Water Licence Inspection Report

Authorization	Representative
2AM-MEA1530	**Robin Allard**
Authorization No. / Expiry	**Representative's Title**
March 27, 2030	**General Supervisor Environment**
Inspection Date	**Inspector**
May 29, 2026	**RMO Kyle Amsel**
Other Authorization/s	
Activities Inspected	
☐**Municipal** ☒ **Camp, Commercial** ☐ **Drilling** ☒ **Mining** ☒ **Construction** ☒ **Reclamation** ☒ **Fuel Storage** ☒ **Roads/Hauling** ☐ **Winter Hauling** ☐ **Camp, Private** ☐ **Other** Click or tap here to enter text.

On May 29, 2026 Resource Management Officer Kyle Amsel (Inspector) for Crown-Indigenous Relations and Northern Affairs Canada conducted an Inspection of Water Licence 2AM-MEA1530 (Licence) issued to Agnico Eagle Mines Ltd. (Proponent) for use of water and deposit of waste in support of a Mining Undertaking (Undertaking).

Photo #	2	**Coordinates:**	N65^0 1’ 11” W96^0 4’ 21”

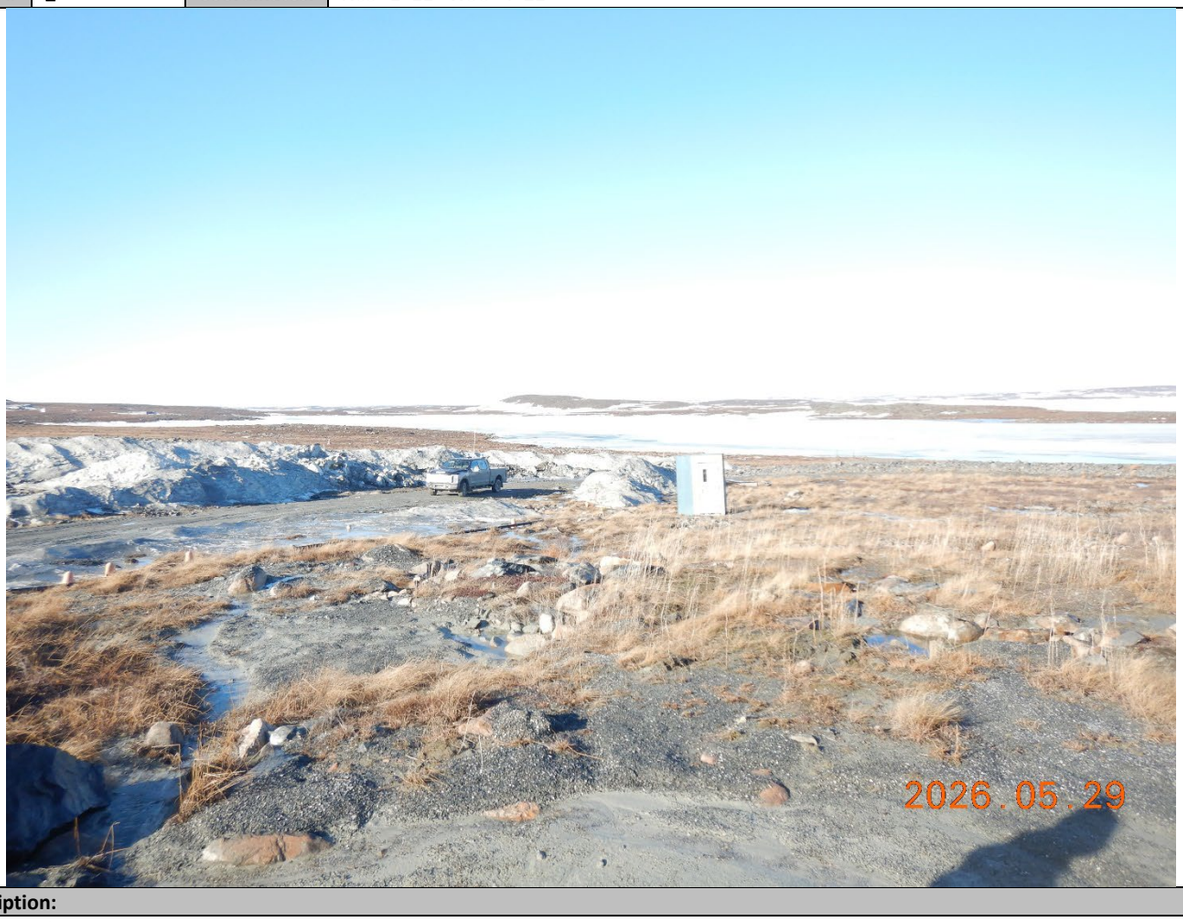
1) At the time of Inspection water usage at ST-1 Third Portage Lake water barge was 227,509m^3 (Photo 1)
2) Mill Seep (Photo 2)
   a) The Mill Seep is actively flowing and Year-To-Date (YTD) recovery has totalled 5,156m^3

b) Leach pad repairs have been completed.
   c) There have been no hits for weak acid dissociable cyanide.
3) Goose Pit (Photo 3)
   a) There is a bubbler operational on the pit to help meet water quality targets in the pit for ammonia and Thiocyanide.
